RAIL COACH FACTORY, KAPURTHALA

CAI N O.: ED/CAI/026 Dated: 27.12.2023

COACH ALTERATION INSTRUCTION SHEET FOR MODIFICATIONS IN EXISTING LHB NON AC SCN TYPE COACHES

This Coach Alteration Instruction Sheet has been issued for modification in existing **LHB Non AC SCN type coaches** wherein following steps are to be taken for modifications in the coach:

SCALE	SSE/ED	
	CHD	
	DRN	
REF.DRG.NO.	NIL	
PL NO.	NIL	
DRG.NO.	SKED-935	
ALT. NIL	SIZE A3	SHEET 2/2

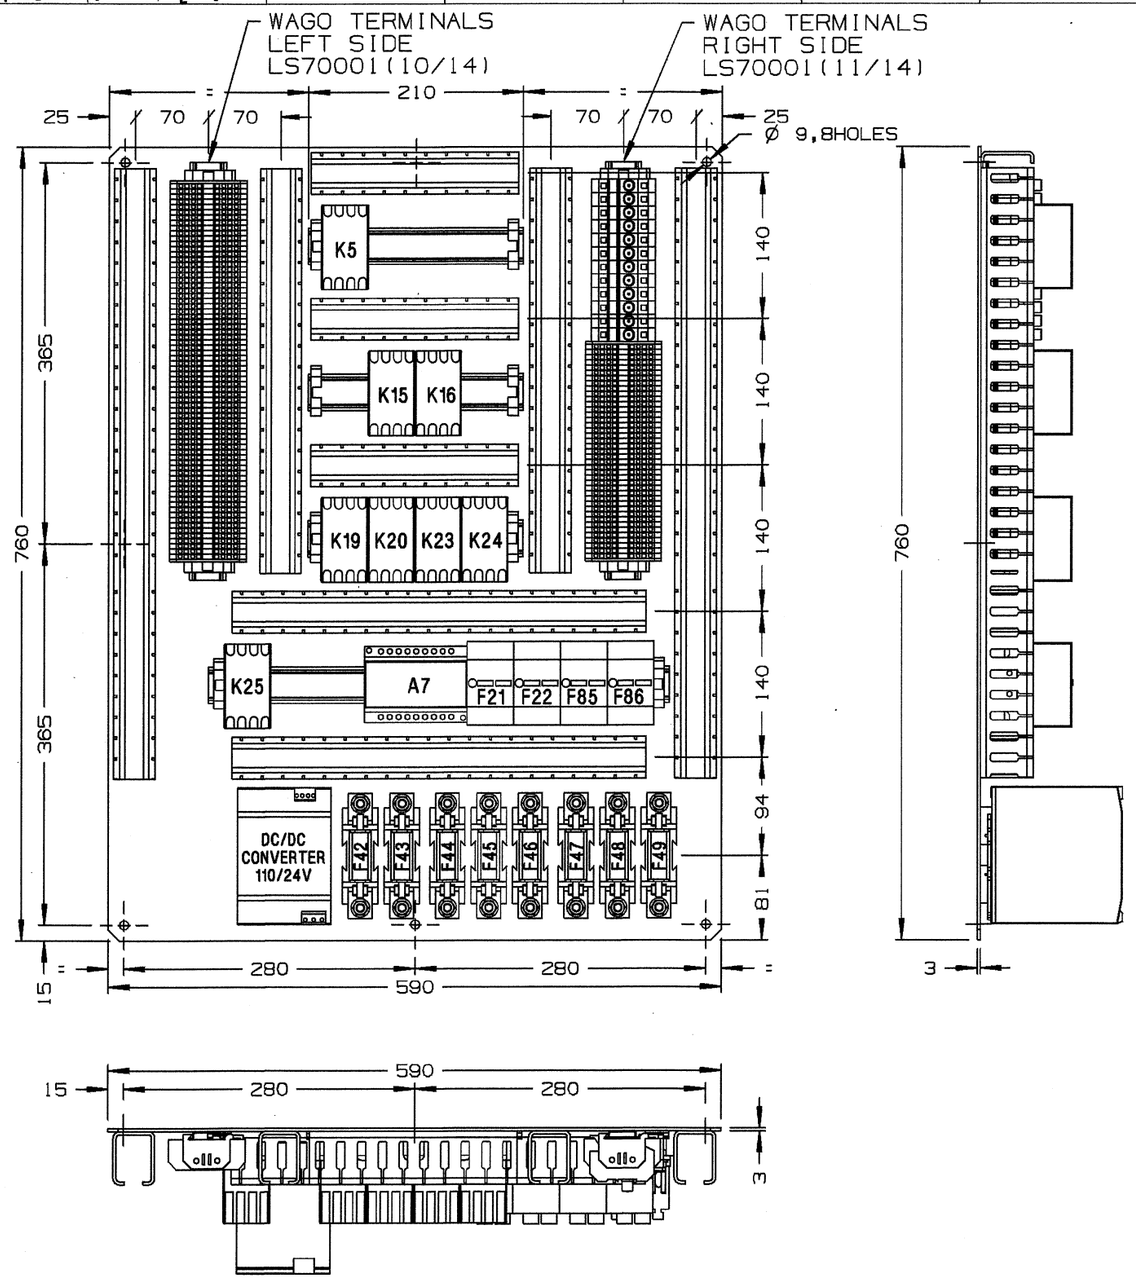
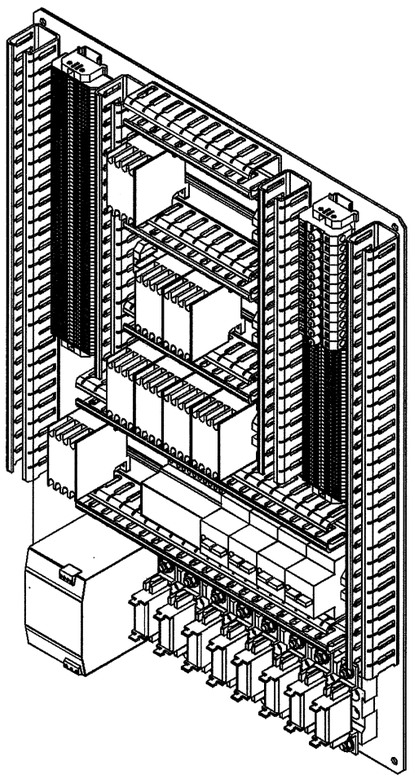
D	Modifications in the Structural drawing of the SBC :	
D.1	**Drawing no LS70201 sheet 3/14 Revised to drawing no SKED 935 sheet - 1**	
	1	Contactors 32K10/+S1K11, 32 K12/+S1K14, 32 K13/+S1K13, 32 K15/+S1K17, MR9, 110 V 32U3/+S1U2.3, 32K05/+S1K08 deleted, drawing revised
D.2	**Drawing no LS70201 sheet 6/14 revised to drawing no SKED 935 sheet - 2**	
	1	MCB re-arranged :as per reference-E
D.3	**Drawing no LS70201 sheet 1/14 revised terminal codifications chart.**	
	1	Terminal no. 83 to 86 changed to 280-837 of M/s WAGO in-place of 280-833 of M/s WAGO

NOTE:- 1. ALL DIMENSIONS IN MM.
2. REF. DRG. NO.LS70201 (SHEET-3/14).
3. S1K11,S1K8,S1K13,S1K14,S1K17,S1K48 & S1A6 DELETED.
